Access Compliance Report

Public Rights-of-Way

(Curb Ramps)

Intersection ID: 10033070	Main Street: NORTH_COMMUNITY_HOUSE_RD	Cross Street: N/A	Location: SE
ADA ID: 5C3C773E209F	Ramp Type: Perp	Initial Pass/Fail: Fail	Overall Compliance: No
Severity Score: 33.75			
Codes/Mitigation Info/Possible Solution		Field Measurements/Component Compliance

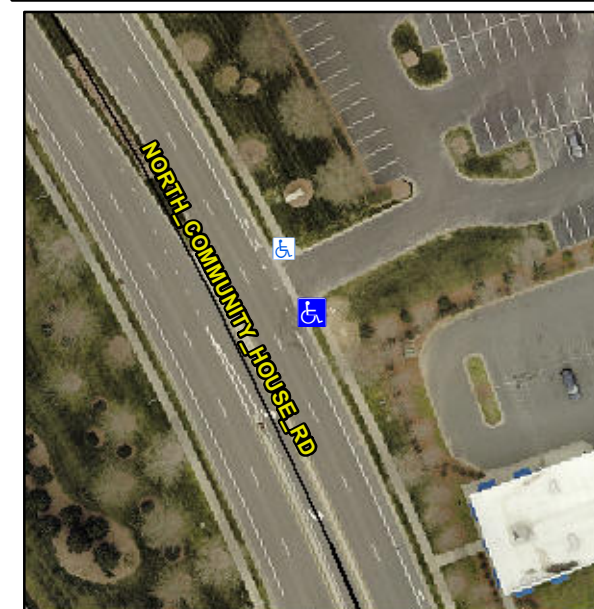
Not Found, R304.5.1, R304.5.3

Compliance	Description	Data	Compliance	Description	Data
N/A	Ramp Length (in)	56.5	Yes	Ramp Slope (%)	6.0
No	Ramp Width (in)	40.0	No	Ramp XSlope (%)	7.6
N/A	Flare Type LT	N/A	N/A	Flare Type RT	N/A
N/A	Flare Slope LT (%)	N/A	N/A	Flare Slope RT (%)	N/A
N/A	Flare Traversable LT?	N/A	N/A	Flare Traversable RT?	N/A
N/A	Landing Length (in)	N/A	N/A	DWS Provided?	N/A
N/A	Landing Width (in)	N/A	N/A	DWS Contrast?	N/A
N/A	Landing Slope (%)	N/A	N/A	DWS Length (in)	N/A
N/A	Landing X Slope (%)	N/A	N/A	DWS Full Width?	N/A
N/A	Landing Curb? (Y/N)	N/A	N/A	DWS Offset (in)	N/A
N/A	Shared Landing?	N/A			
N/A	Gutter Ponding?	N/A	N/A	Gutter Slope (%)	N/A
N/A	Gutter Lip Ht (in)	N/A	N/A	Gutter X Slope (%)	N/A
N/A	Painted X Walk1?	No	N/A	Painted X Walk2?	N/A
	X Walk 1 Direction	To NW		X Walk 2 Direction	N/A
N/A	X Walk 1 Width (in)	N/A	N/A	X Walk 2 Width (in)	N/A
	X Walk 1 Slope (%)	1.0		X Walk 2 Slope (%)	N/A
	X Walk 1 X Slope (%)	1.5		X Walk 2 X Slope (%)	N/A

Remove & Replace Entire Ramp.
